Field campaign

Topic	Mulsanne side view camera control module (SC12/15)
Market area	Worldwide Bentley (1WBE)
Brand	Bentley
Transaction No.	2030874/3
Campaign number	E775
Note	E775
Type	
US code

Mulsanne

Figure 1

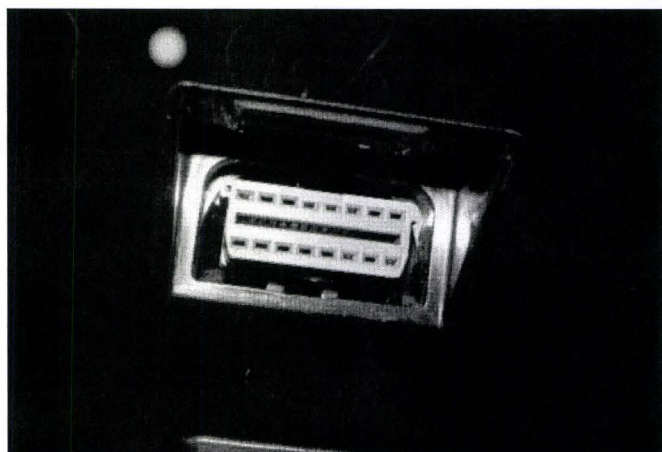
Should the vehicle still have the original side view camera module fitted or the link loom was installed at the time of production a Yellow paint mark will not be evident, if this is the case please replace the existing module or remove the link loom and replace with the latest specification part as detailed within this document.

Figure 1

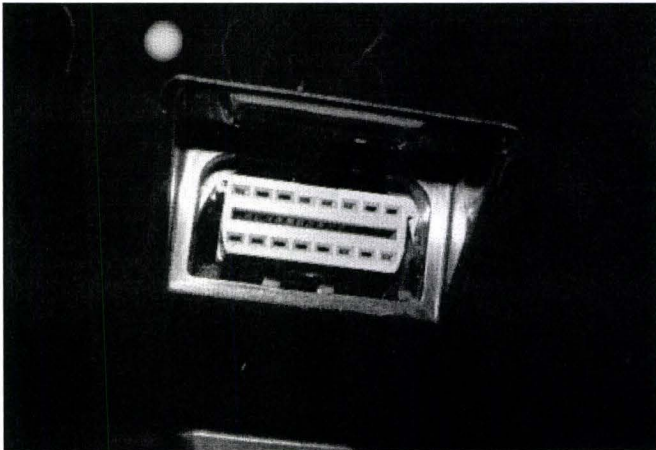
Should the vehicle still have the original side view camera module fitted or the link loom was installed at the time of production a Yellow paint mark will not be evident, if this is the case please replace the existing module or remove the link loom and replace with the latest specification part as detailed within this document.

3. Should the original side view camera control module have been previously removed and replaced with the link loom 3Y0 998 381 there should be a Yellow completion paint mark on the diagnostic plug surrounding cover (Figure 1), please carefully remove this and replace with a White paint completion mark as shown in Figure 2. If the original control module has been replaced for the latest specification part or the factory fitted loom has been replaced with the latest specification part, a White paint completion mark should also be added (Figure 2)

1. Remove the side view control module temporary link loom or remove the existing side view camera control module - Refer to Workshop Manual Rep.Gr 94
2. Fit the latest specification control module - Refer to Workshop Manual Rep.Gr 94

Figure 2

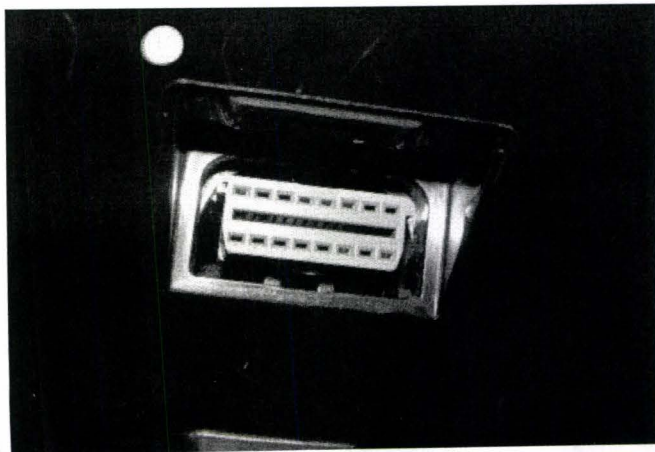
If the vehicle is not already listed as repaired in "Repair history" (in Elsa pro), check for the Campaign completion identification mark which is a White paint mark located above the diagnostic plug cover (Figure 2) the White mark confirms the latest specification part has been fitted, should neither be evident carry out the required work in accordance with instructions.

White paint mark on the diagnostic plug surrounding cover confirms the latest specification part has been fitted.
